Your Vehicle: 2006 Mazda Mazdaspeed6 L4-2.3L Turbo

Drivetrain - Oil Seepage From Transfer Case

Bulletin No: 03-001/08

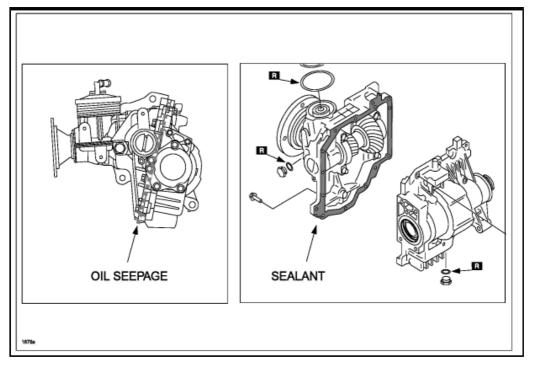
Some vehicles may experience oil seepage from the transfer case in the location shown.

This may be caused by insufficient cleaning of the mating surfaces of the front and rear cases before applying sealant.

3. Completely remove sealant and oil off contact surfaces and bolt holes of both case halves with Brake Clean.

- 4. Apply locally sourced Permatex Ultra Grey RTV sealant to <u>case</u> as shown.
- 5. Reinstall transfer case according to Workshop Manual (section 05-17 TRANSFER REMOVAL/INSTALLATION).
- 6. Verify repair.
